TF-BTA 7th Meeting

Assessment of Proposals for the Determination of the Test Area and the Test Execution

**on behalf of the
VDA ad-hoc Working Group Pedestrian Protection**

1. Determine Lower and Upper Bumper Reference Lines?

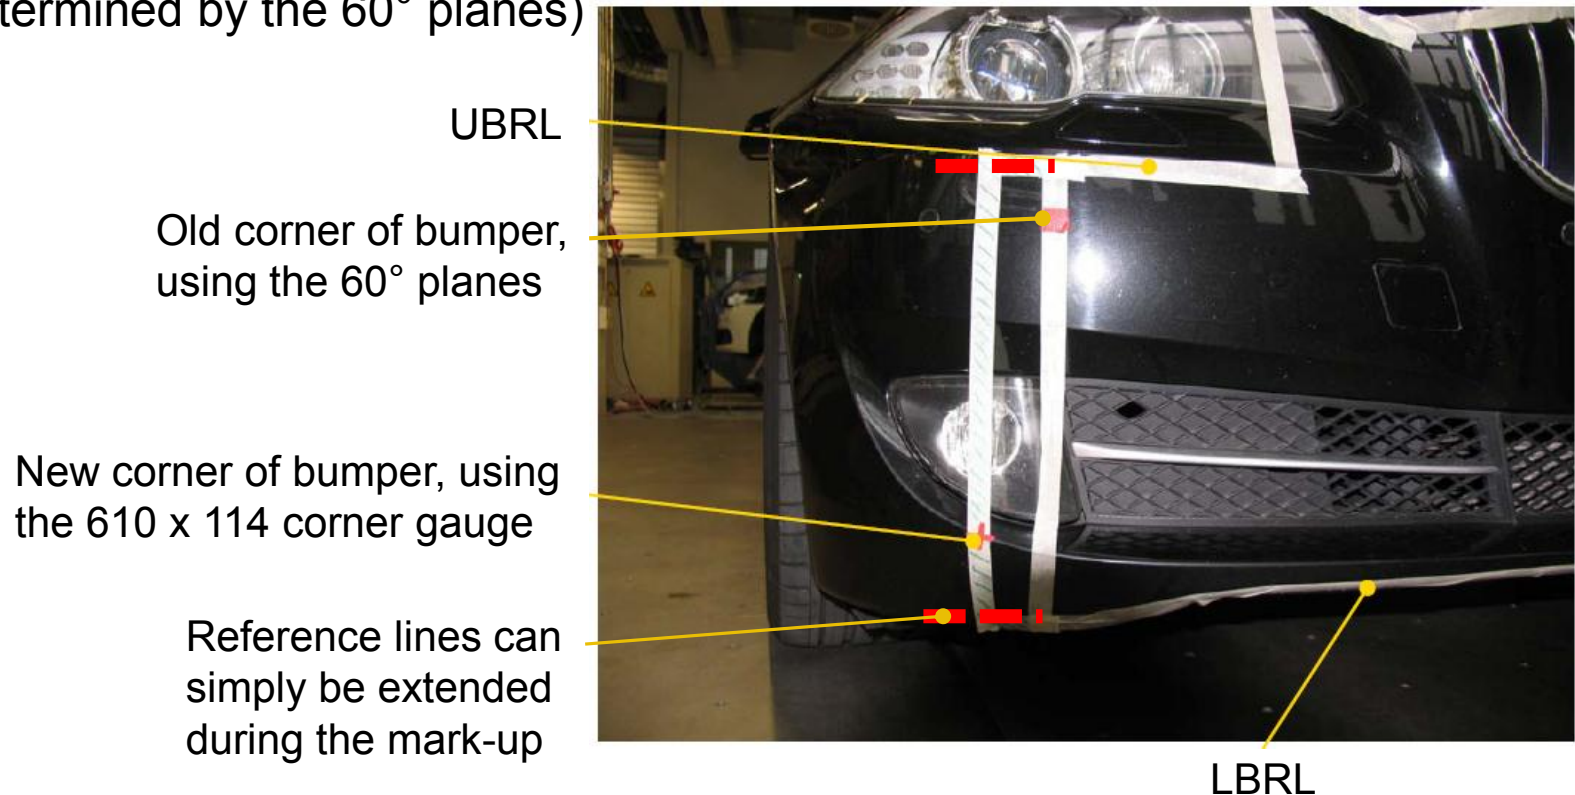
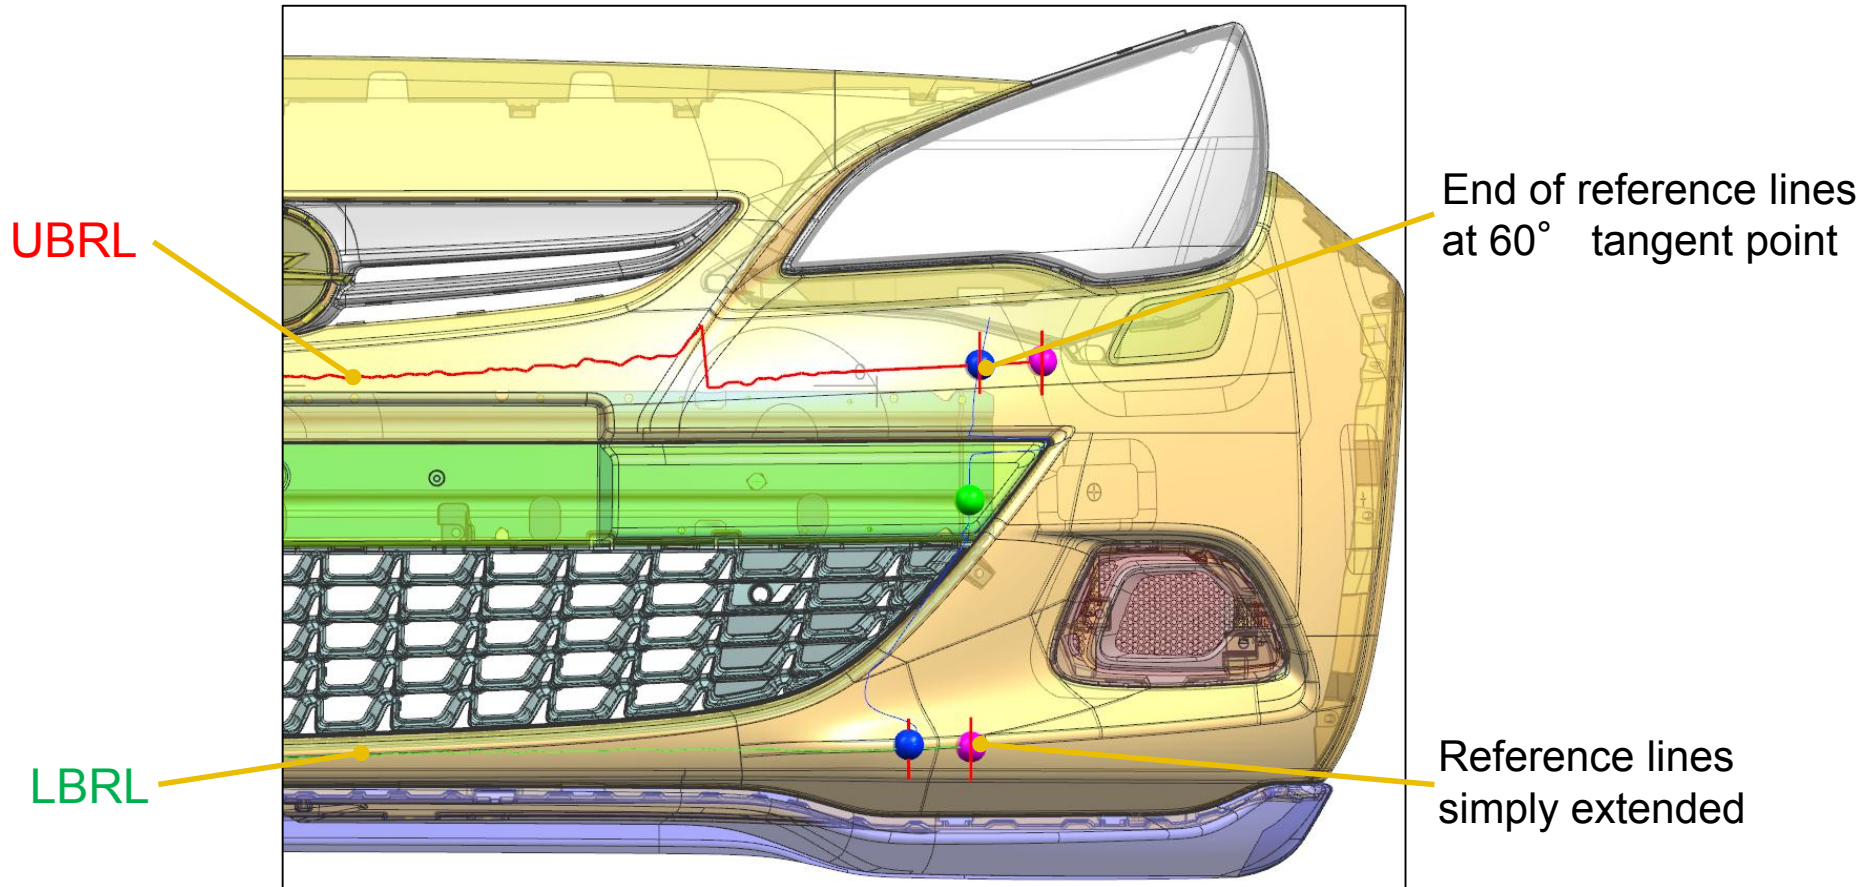
- For a “physical” determination of the LBRL and UBRL it seems sufficient to just extend the reference lines within the former corner of bumper (determined by the 60° planes)

Pendulum acc. to UN R42

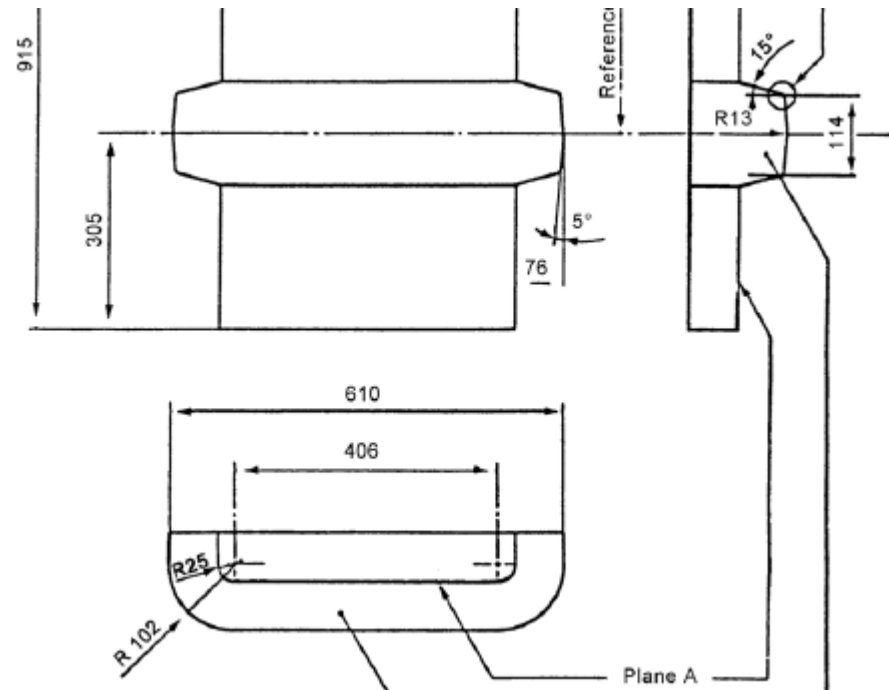
- Corner gauge idea was developed during the discussion of the TF-BTA, using a surface with a similar size as the surface of the pendulum in UN R42
- Could a smaller surface be sufficient?

2. Use Smaller Corner Gauges?

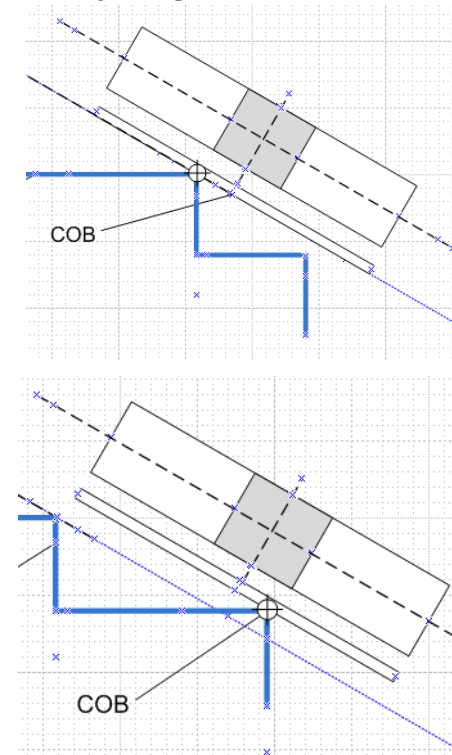
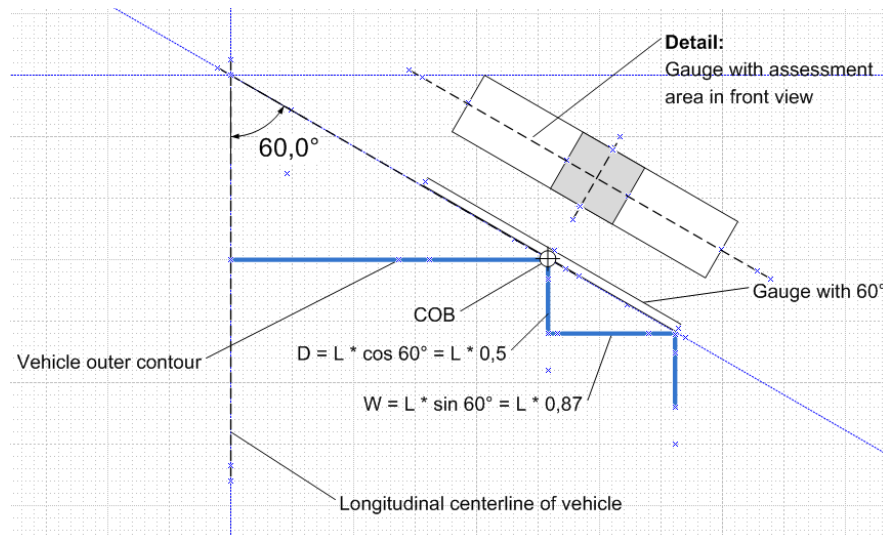
- Sizes (width and/or depth) of possible jumps in the bumper surface certainly depend on the size of the corner gauges
- Pictures shown do NOT represent typical vehicle styling!

Original CoB
@ Y = -452

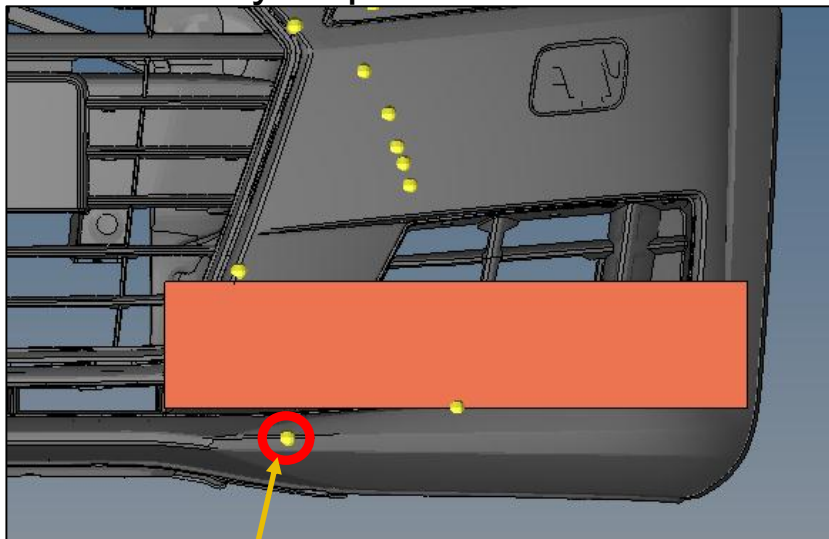
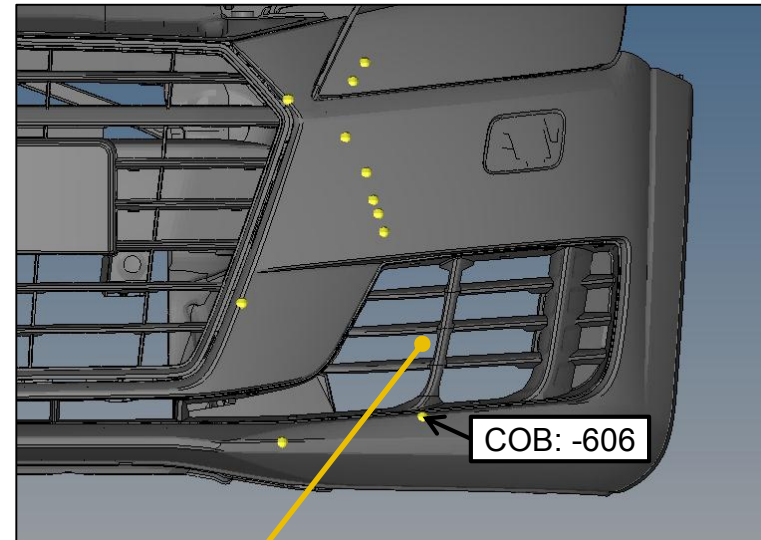
- CoB shall represent general vehicle outer surface and must not be determined by localities like air intake openings, which may be required to compensate for loss of openings in center area due to pedestrian safety requirements.

Large air inlet, needed to compensate the decrease of air inlets in the vehicle center

2. Use Smaller Corner Gauges?

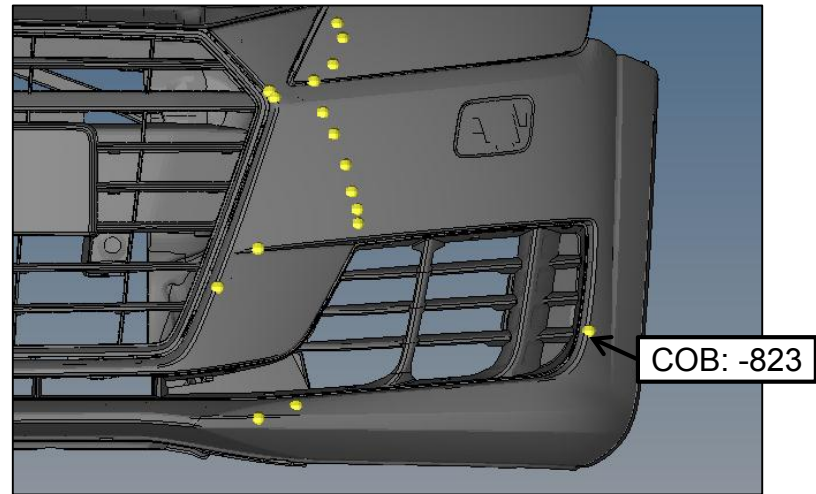
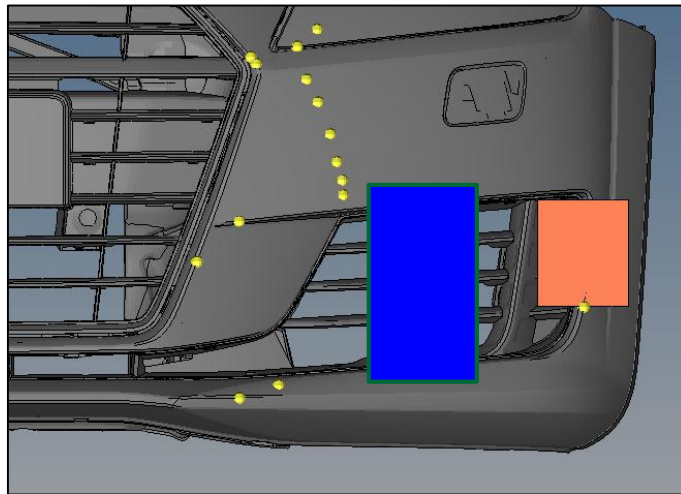
- Small corner gauges lead to over-assessing single styling elements that have technical functionalities but that do not have any influence on pedestrian safety (example 1)

2. Use Smaller Corner Gauges?

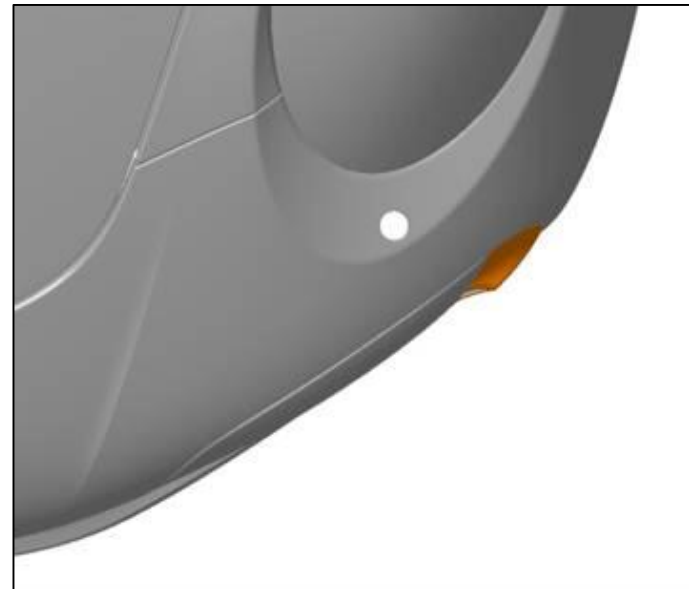
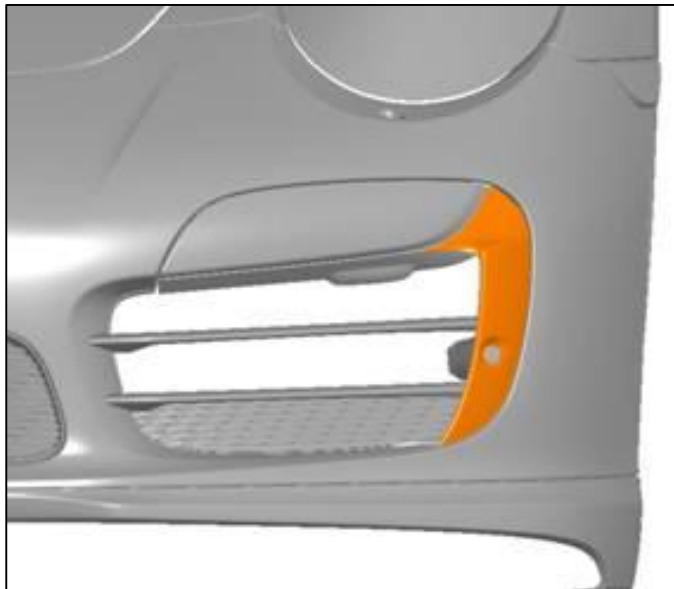
- Small corner gauges lead to over-assessing single styling elements that have technical functionalities but that do not have any influence on pedestrian safety (example 2)

2. Use Smaller Corner Gauges?

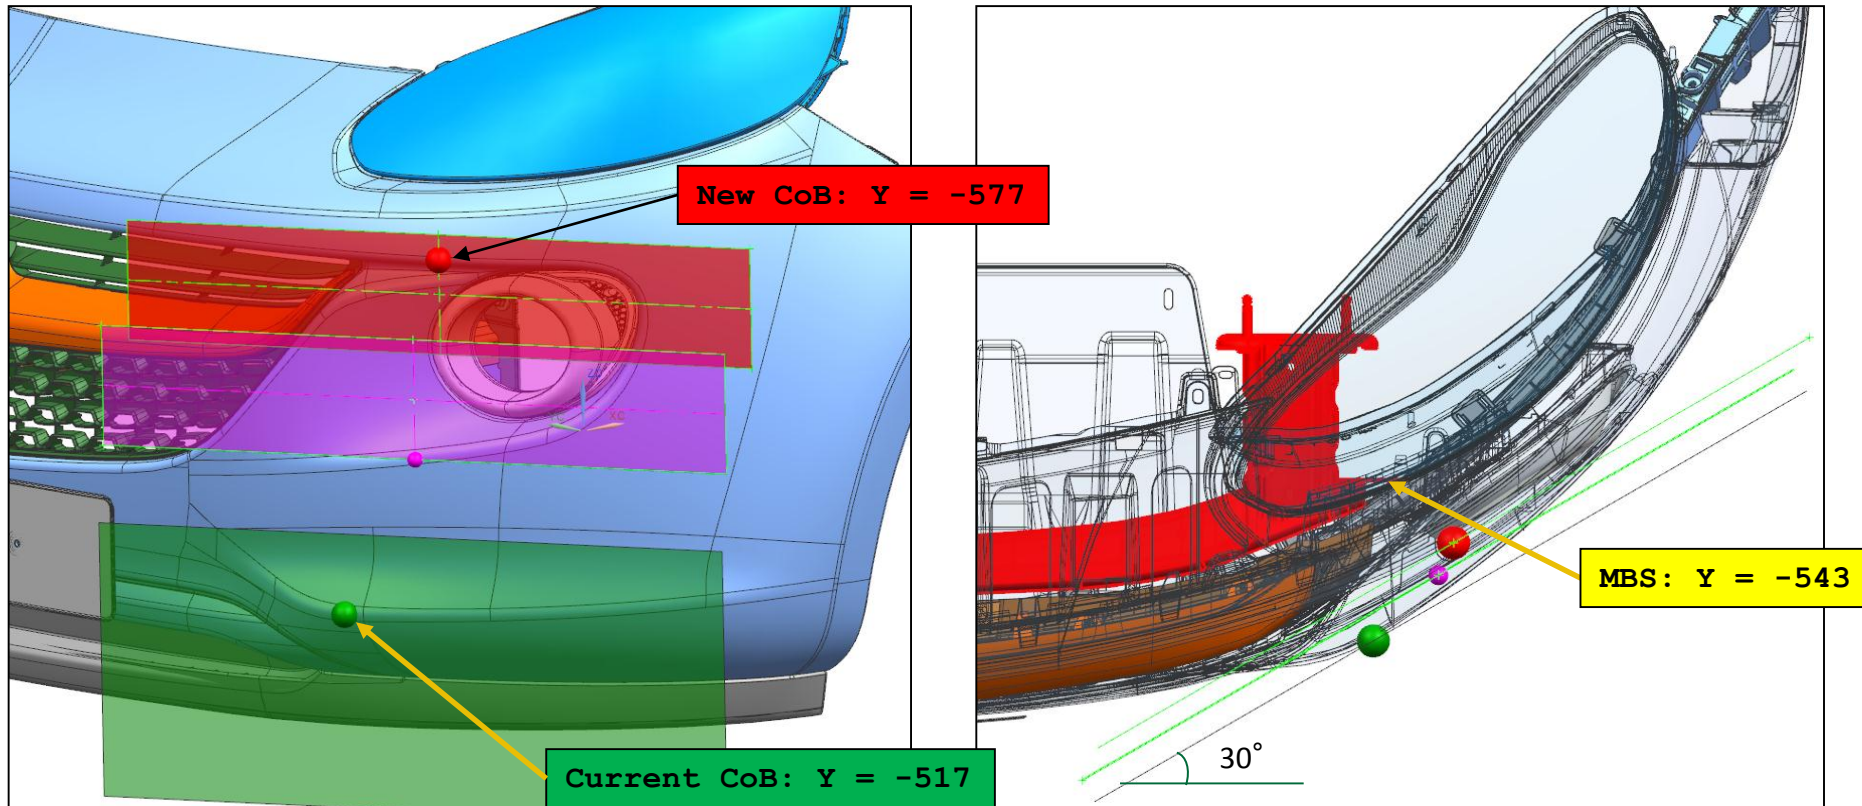
- Corner points do not change in each and every case but still a risk of over-assessing certain styling elements can be seen

2. Use Smaller Corner Gauges?

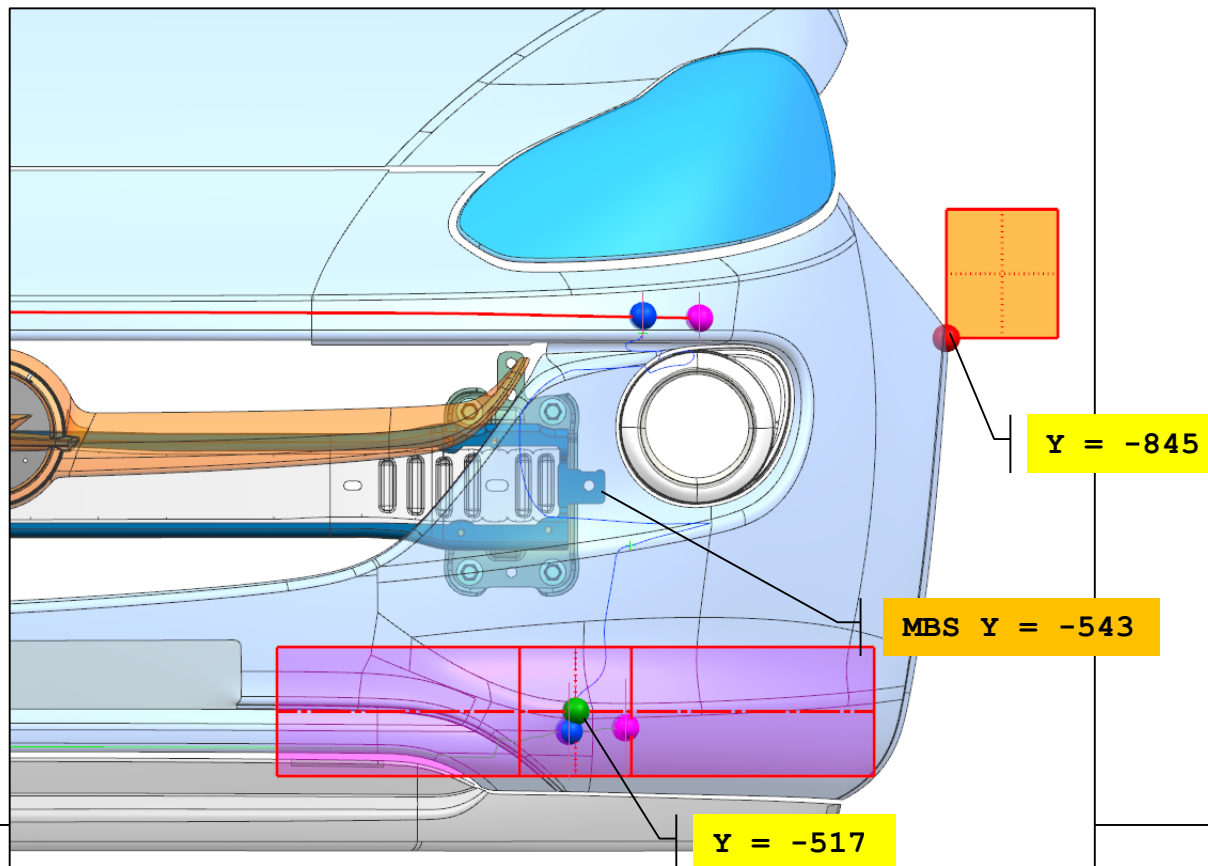
- In all cases, corner gauges will contact the wheel arches if “any contact” to the device is required
